Report to the Future Melbourne (Planning) Committee

**Planning Permit Application: TP-2015-906
88 Park Street South Yarra**

DELEGATED PLANNING APPLICATION REPORT

Application number:	TP-2015-906
Applicant:	George Nedovic
Address:	88 Park Street, SOUTH YARRA VIC 3141
Proposal:	Demolition of the existing dwelling and construction of a new two storey dwelling
Date of application:	7 October 2015
Responsible officer:	Oh Young Lee

Shadows 1PM 1:100

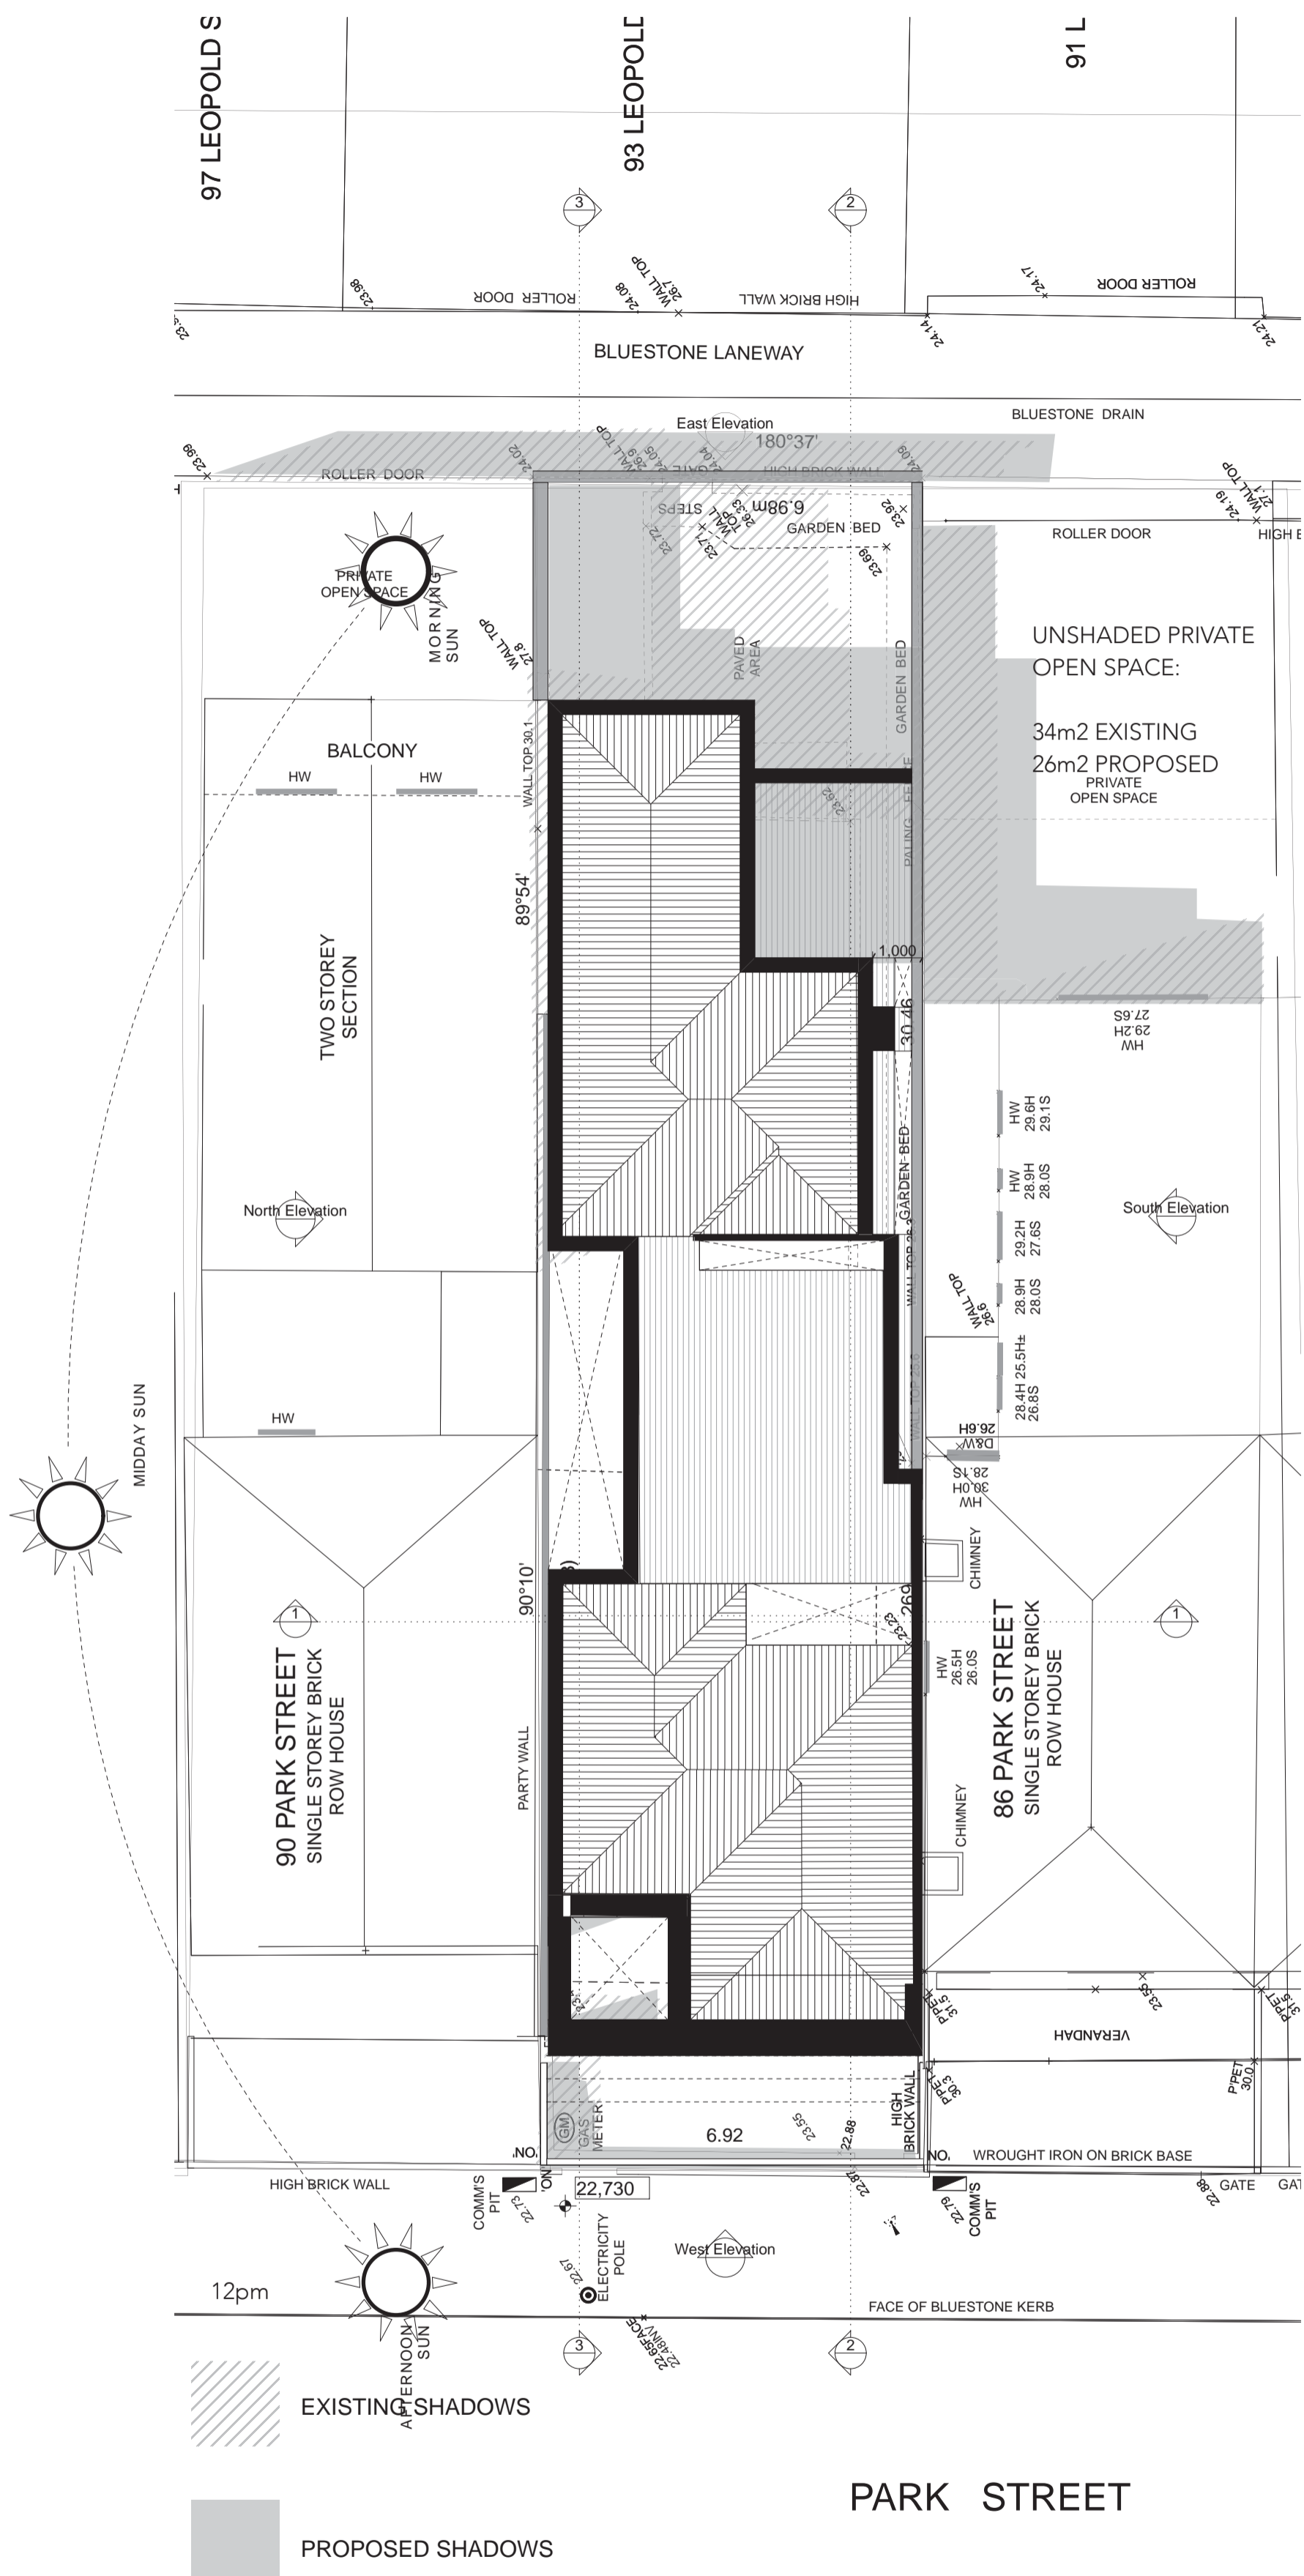
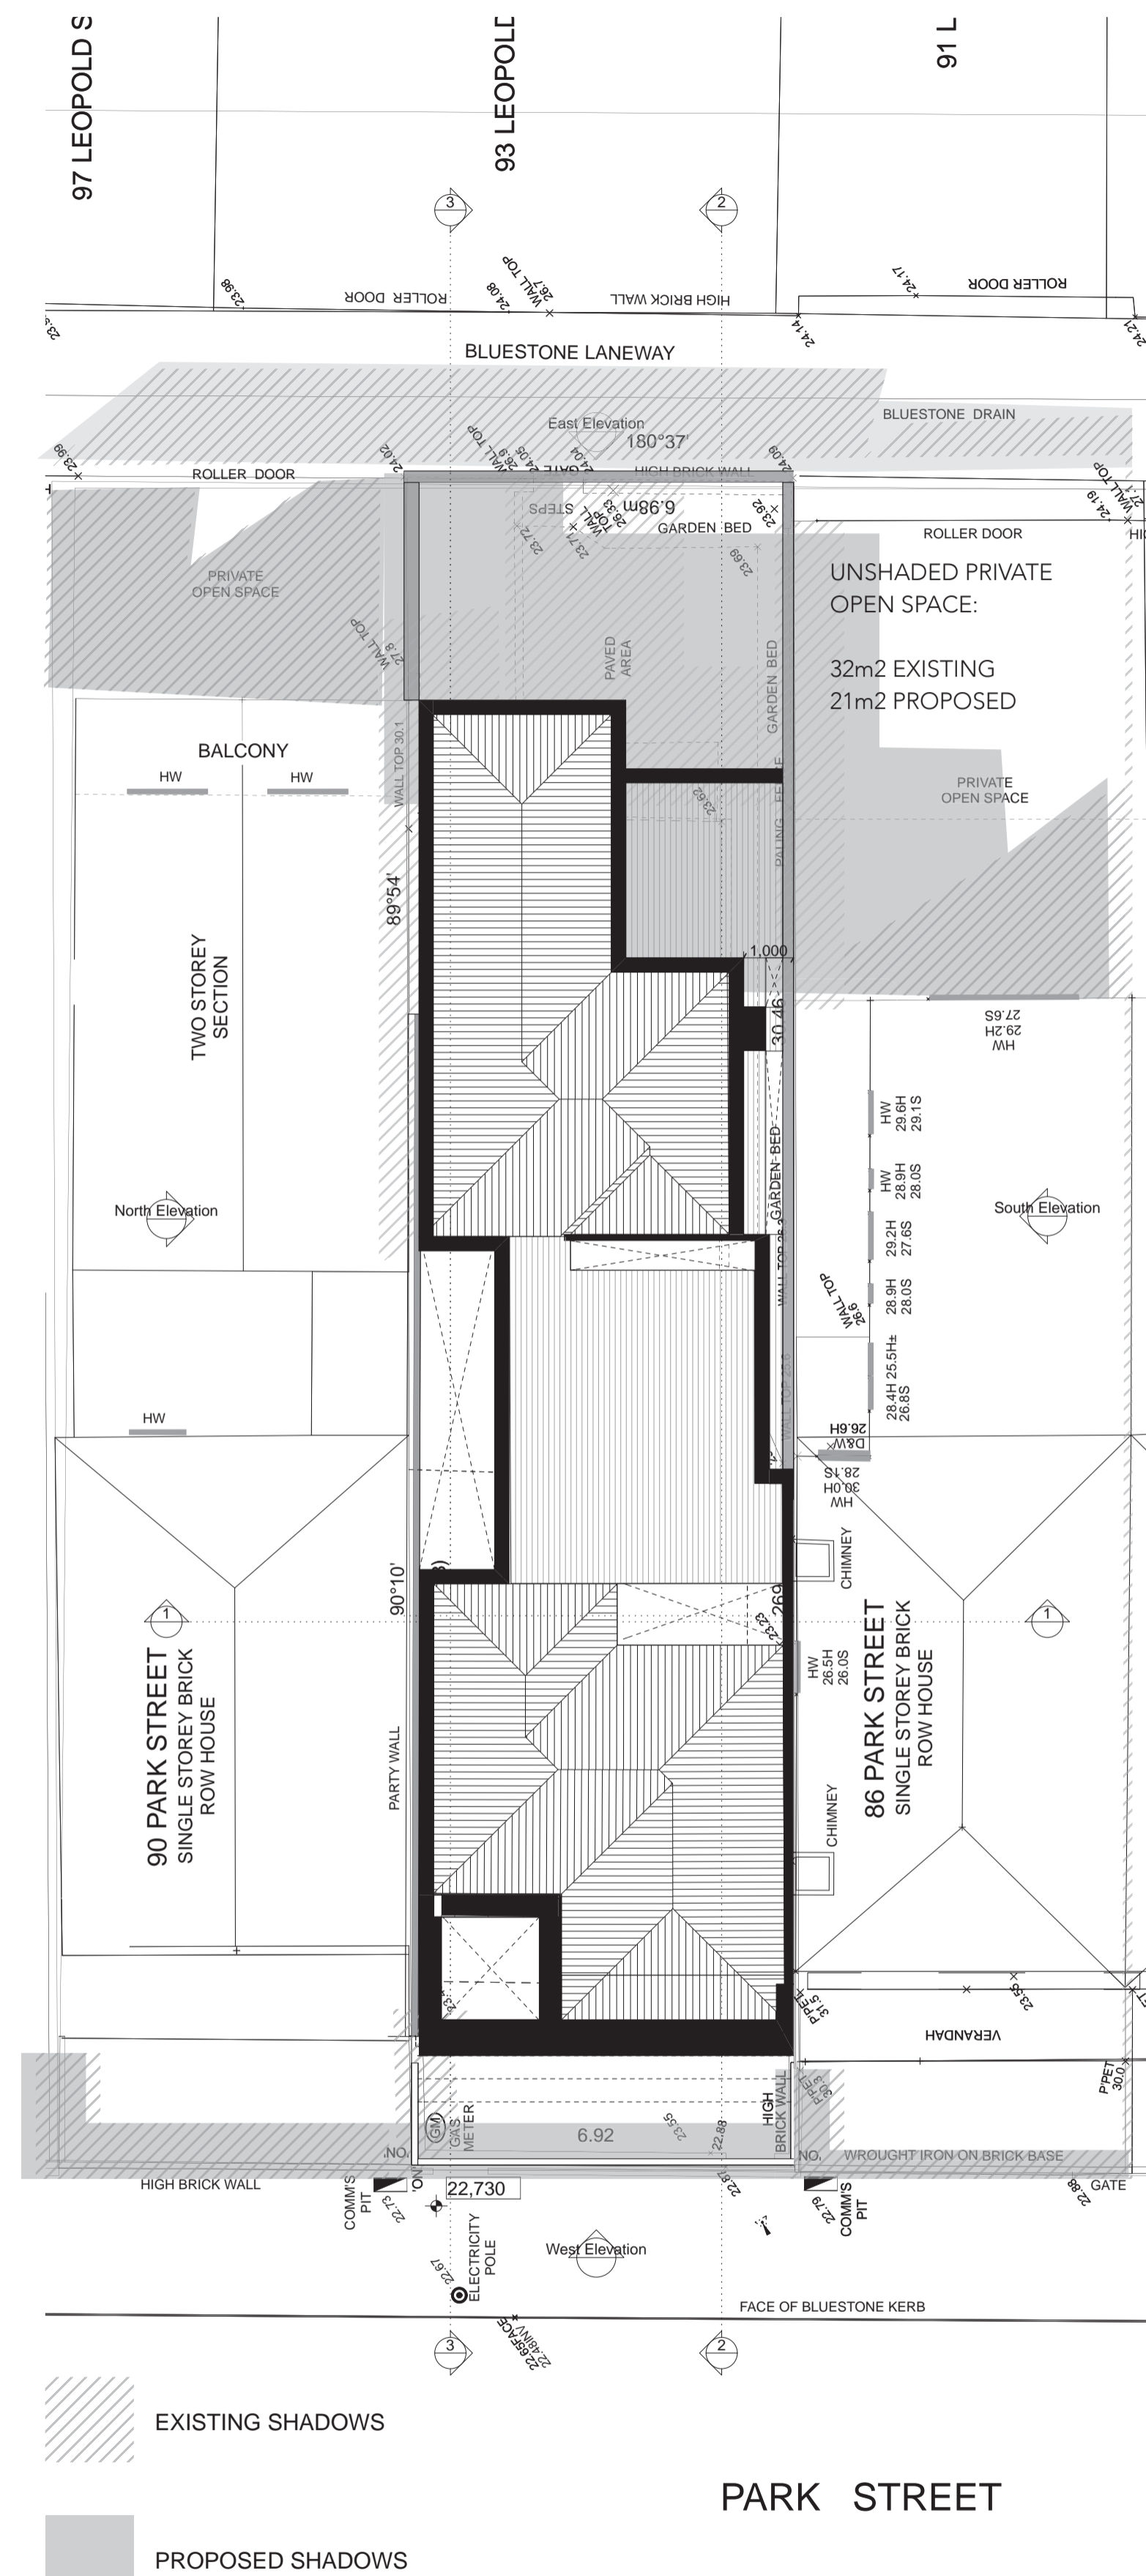
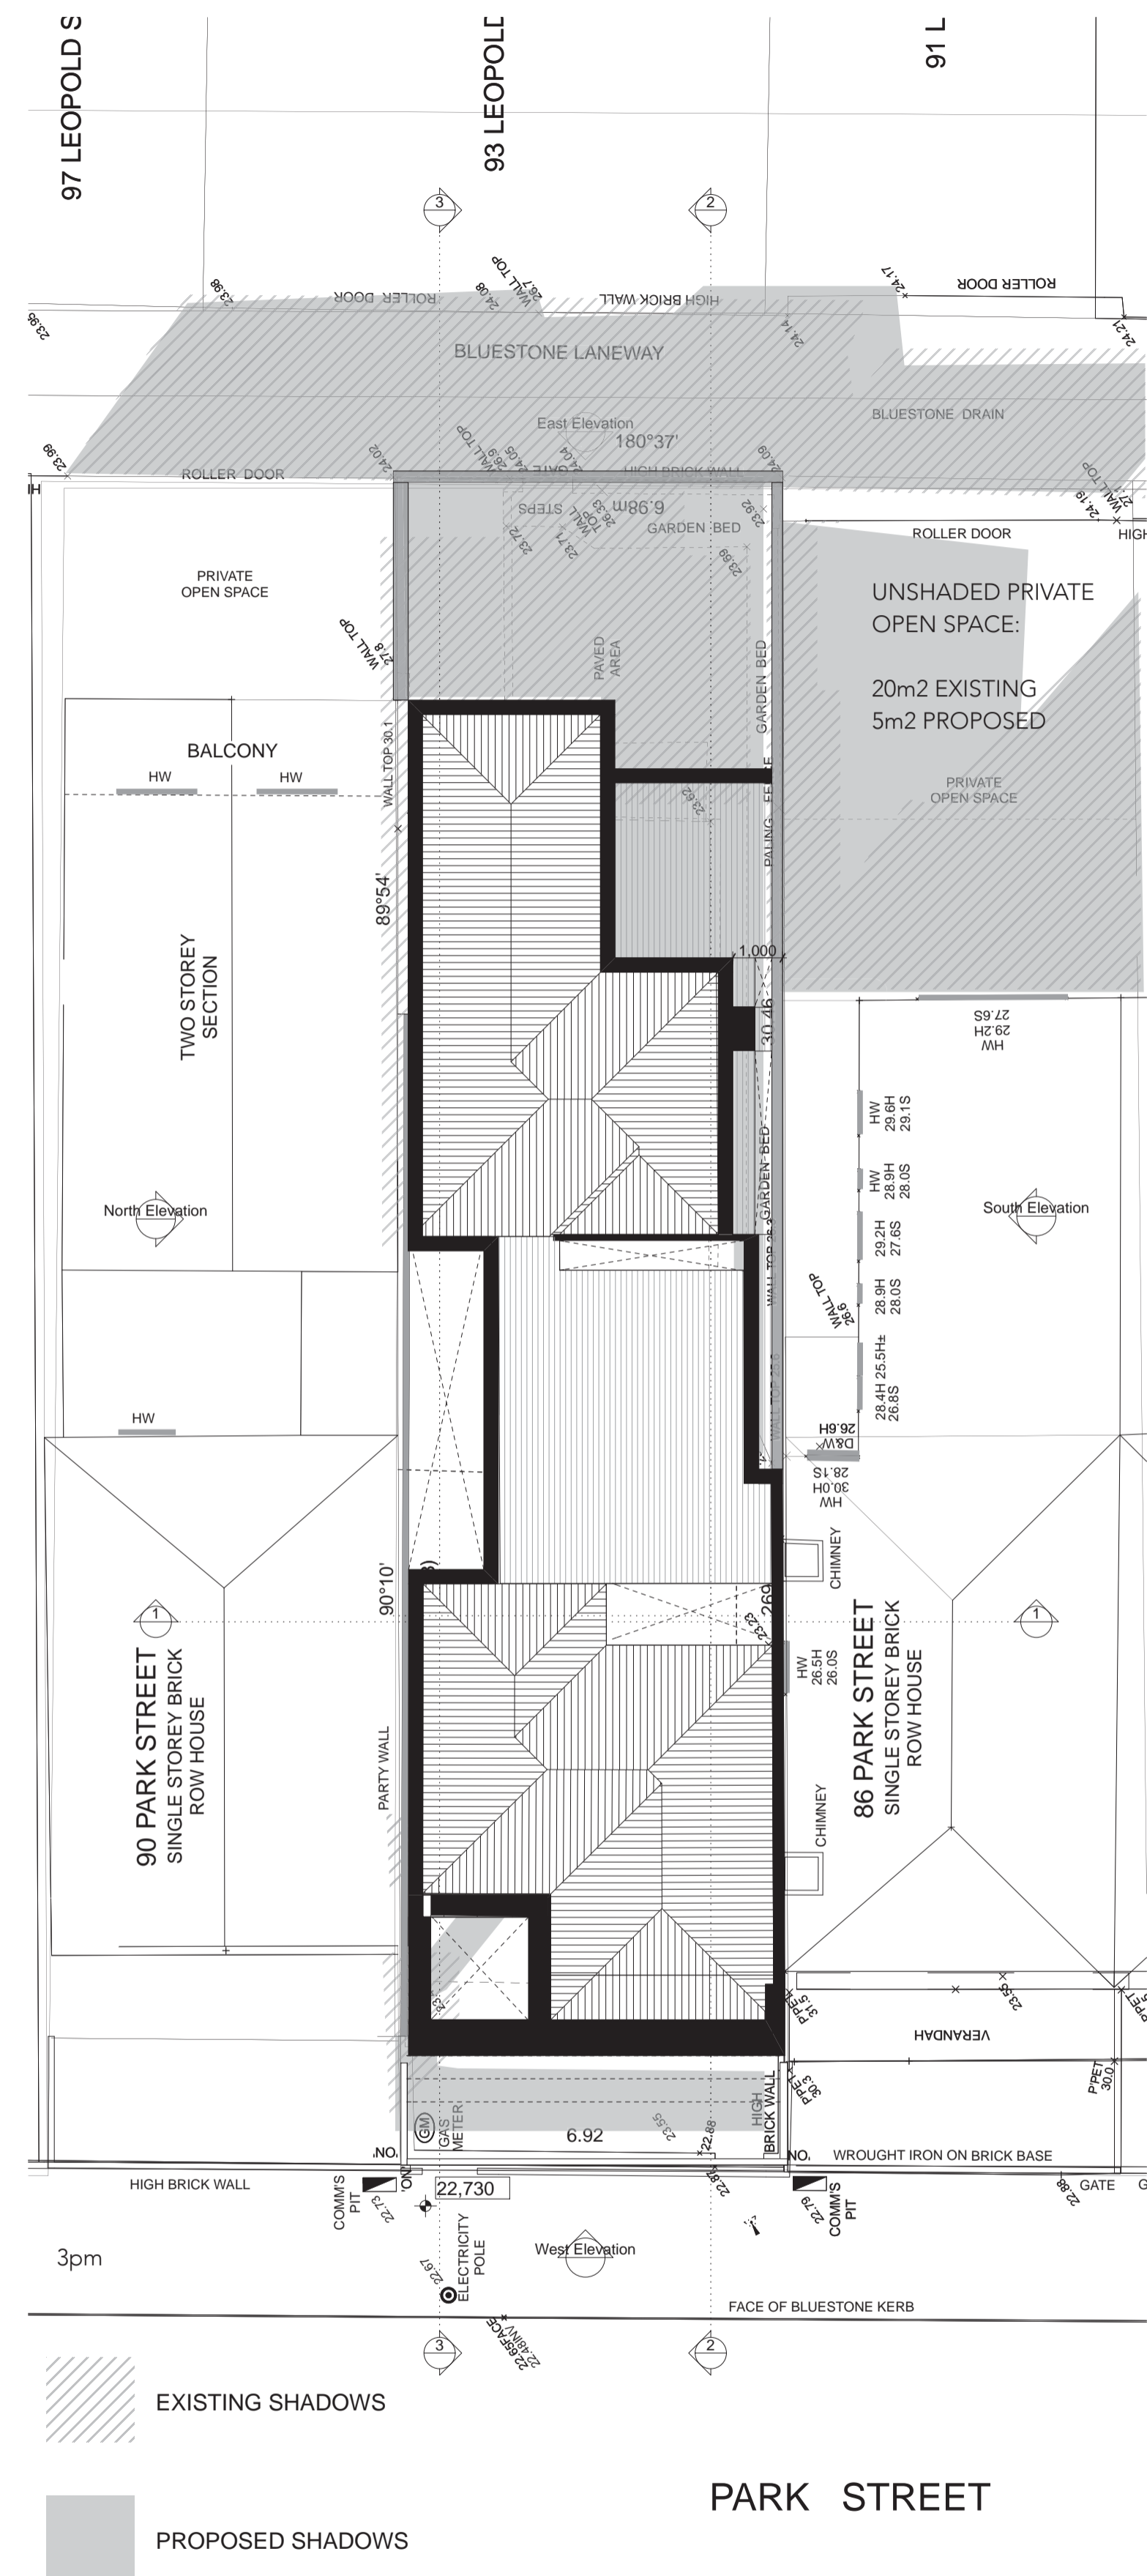
Overall it is considered that no adjoining property will be unreasonably impacted. It is also noted that the shadow diagram provided by the applicant is not reflective of the agreed setback of 1 metre to first floor bathroom and laundry, hence the impact depicted on these plans is likely to be reduced further as a result of this change.

- The existing light court and the skylight which may experience some of shadow from the proposal (although it is unclear from the shadow diagrams) are already overshadowed partially by the existing vegetation along the southern edge of the subject site.
- The applicant has agreed to a condition to provide a minimum 1 metre setback to the first floor walls located adjacent to these skylights, which would further reduce the impact.
- The objective and standard for overshadowing refers to impact on *secluded private open space*, not habitable room windows or private open space.
- It is also noted that the family room has access to daylight through full width glazing directly open to the private open space at the rear of the property and the existing skylight is not the only source of daylight to this room.
